<b>Title - Sujet</b> ATP Integration Facility	
<b>Solicitation No. - N° de l'invitation</b> EZ899-192962/A	<b>Amendment No. - N° modif.</b> 010
<b>Client Reference No. - N° de référence du client</b>	<b>Date</b> 2019-05-27
<b>GETS Reference No. - N° de référence de SEAG</b> PW-\$PWY-022-8592	
<b>File No. - N° de dossier</b> PWY-8-41284 (022)	<b>CCC No./N° CCC - FMS No./N° VME</b>
<b>Solicitation Closes - L'invitation prend fin</b> <b>at - à 02:00 PM</b> <b>on - le 2019-05-31</b>	
<b>F.O.B. - F.A.B.</b> <b>Plant-Usine:</b> <input type="checkbox"/> <b>Destination:</b> <input checked="" type="checkbox"/> <b>Other-Autre:</b> <input type="checkbox"/>	
<b>Address Enquiries to: - Adresser toutes questions à:</b> Lam (PWY), Tian	<b>Buyer Id - Id de l'acheteur</b> pwy022
<b>Telephone No. - N° de téléphone</b> (604) 363-7968 ( )	<b>FAX No. - N° de FAX</b> (604) 775-6633
<b>Destination - of Goods, Services, and Construction:</b> <b>Destination - des biens, services et construction:</b> NRC - Herzberg Astronomy & Astrophysics ATP Integration Facility - Victoria, BC

The Solicitation Amendment 010 is raised to issue Addendum 007.

THE FOLLOWING ADDENDUM SUPERCEDES INFORMATION CONTAINED IN DRAWI

**FENCE CONSTRUCTION**

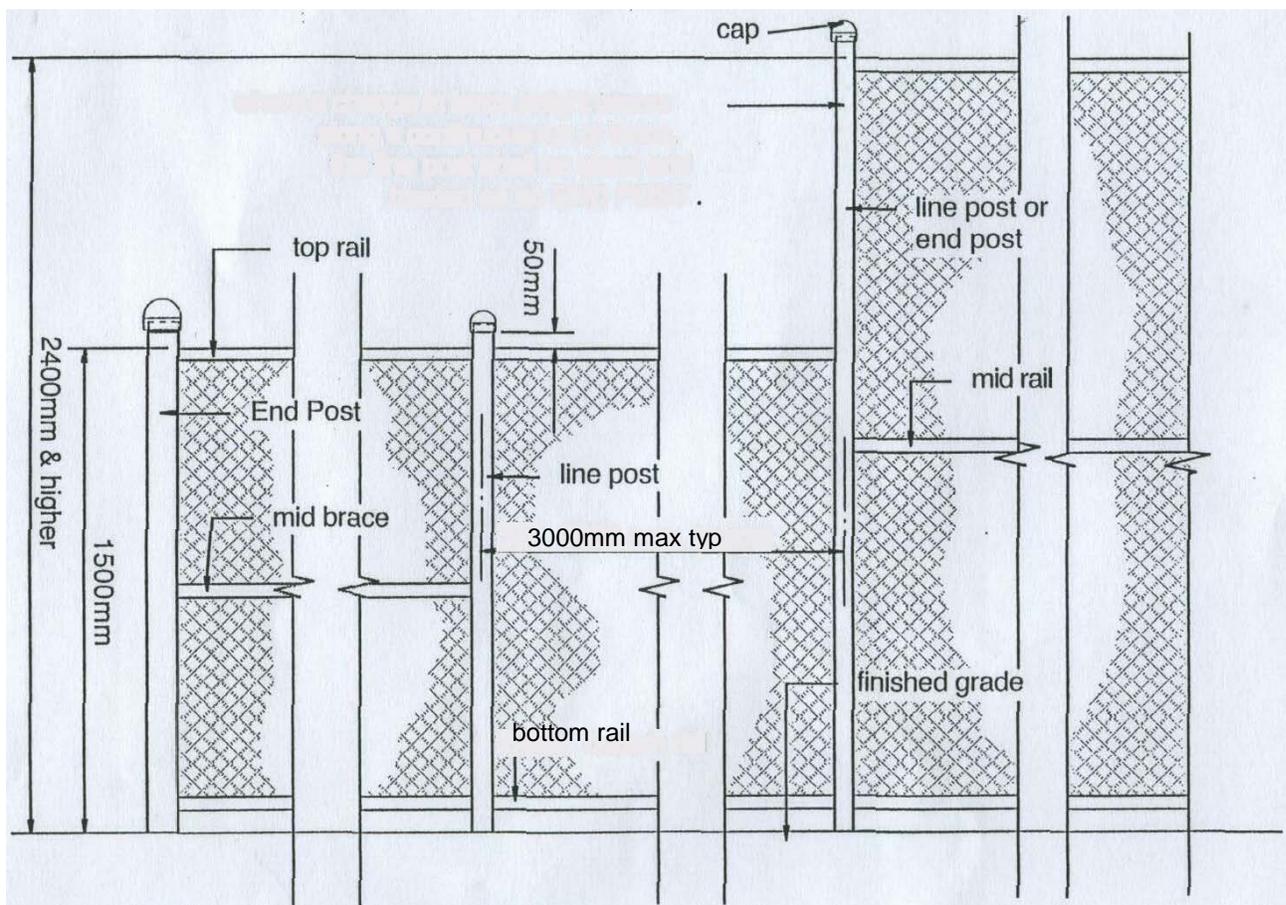
- see tables in this section for sizes and gauges of components
- mid braces shall occur for a minimum one full panel, each side of a corner or bend
- where a change in fence height occurs along a continuous run of fence, the line post shall be sized and treated as an end post
- top rails, bottom rails and mid rails shall be continuous between line posts
- install a continuous mid rail on all fences equal to or greater than 2400mm high
- Post to be a maximum 2.1m spacing to suit maximum width of wire wall. Diagram below is only generic.

**SITE SERVICES BUILDING FIRE  
 PROTECTION PLAN**

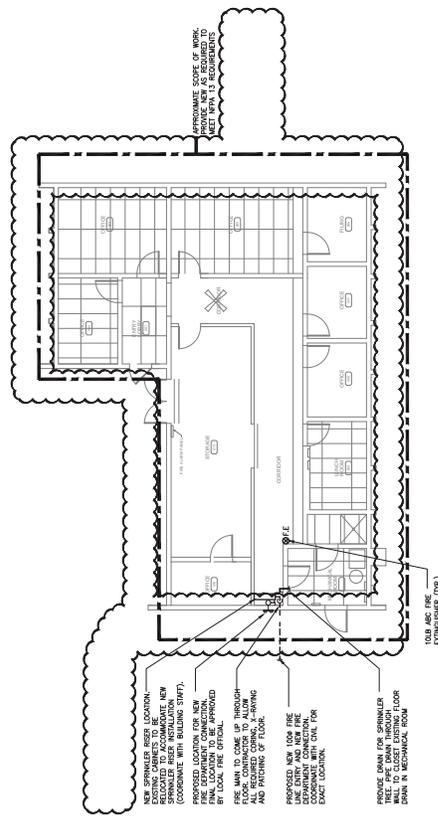
.1 Delete:

- .1 Delete 150mm Ø footing drain from site services building scope of work. See attached sketches for details

**A7. Footing drain is deleted from the scope of contract. Refer to Mechanical Addendum as attached.**
